TO: Recipients of the 52nd Ave S Combined Sewer Overflow (CSO) Reduction Project and Mapes Creek Restoration Project SEPA DNS/Checklist

SUBJECT: Addendum to the 52nd Ave S Combined Sewer Overflow (CSO) Reduction Project and Mapes Creek Restoration Project SEPA Environmental Checklist

SEPA Addendum
52nd Avenue S CSO/
Mapes Creek Restoration

Figure 1

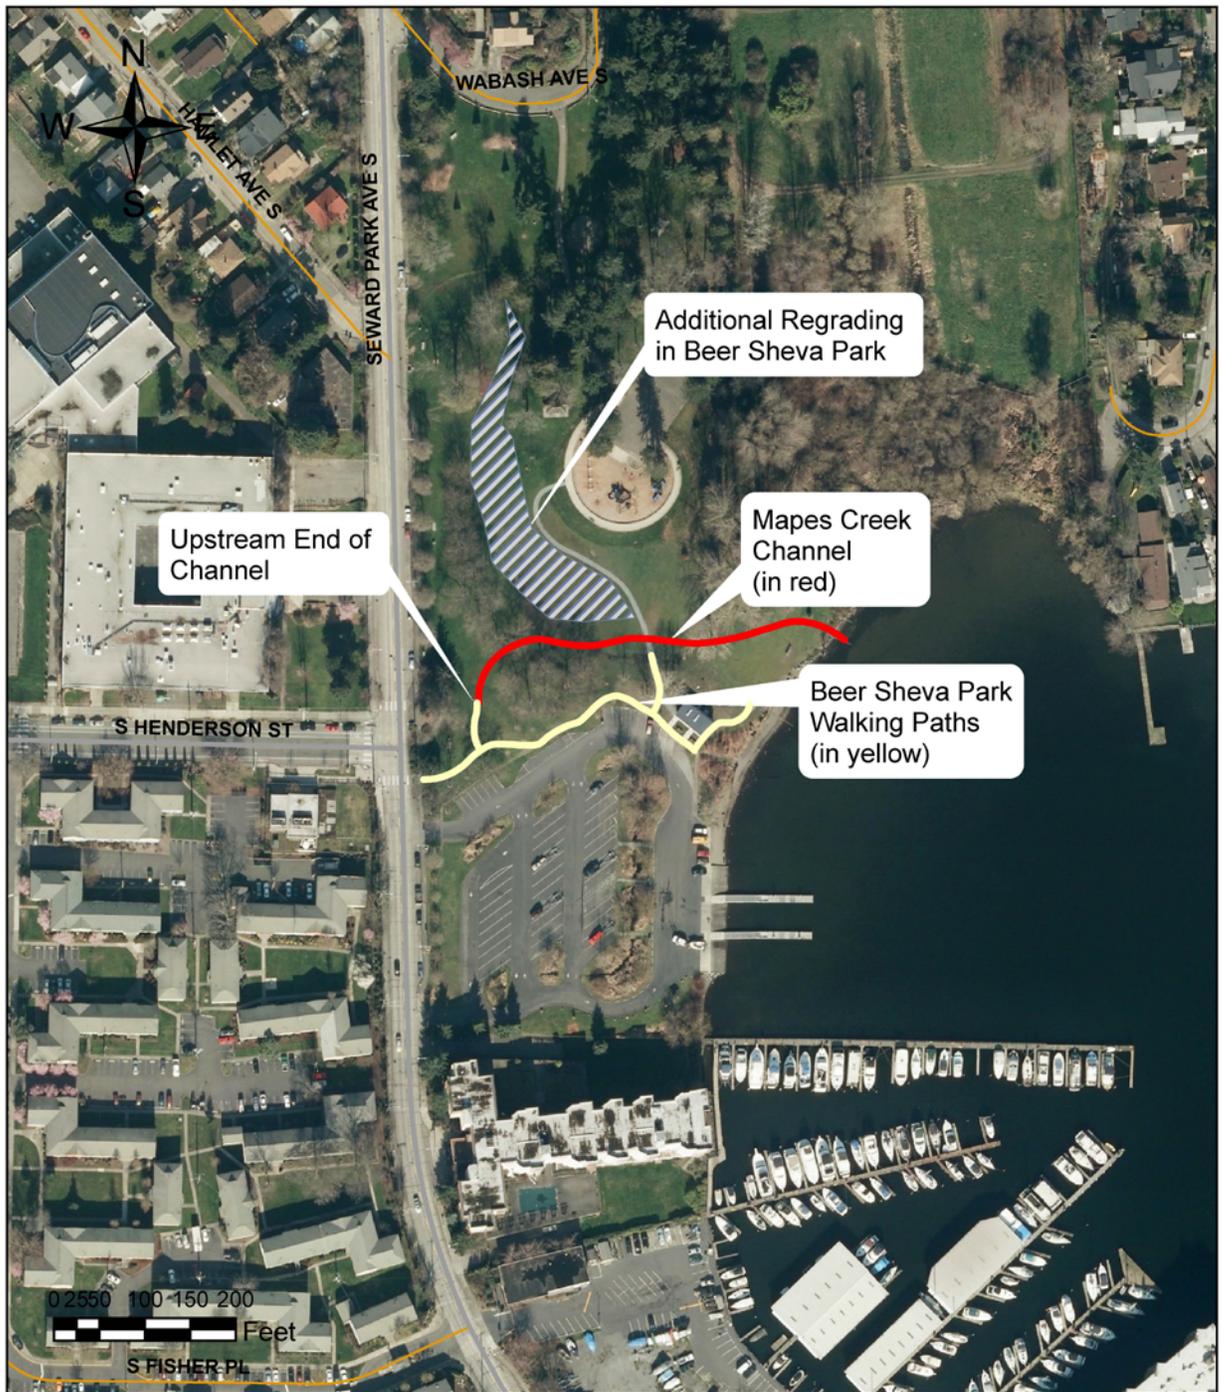
As noted in the 2012 SEPA checklist, the lawn area north of the proposed creek channel (see Figure 1) is low lying and often wet, making it unusable for park users. As part of the Mapes Creek Restoration Project, Seattle Parks and Recreation Department and SPU will grade the wet lawn area to improve drainage by a combination of excavation (approximately 500 cubic yards) and filling (approximately 1,000 cubic yards). On-site excavated soil and topsoil will be reused. Approximately 500 cubic yards of fill material will be imported to complete the grading work. The grading work will increase the usable lawn area and increase recreational opportunities for park users.
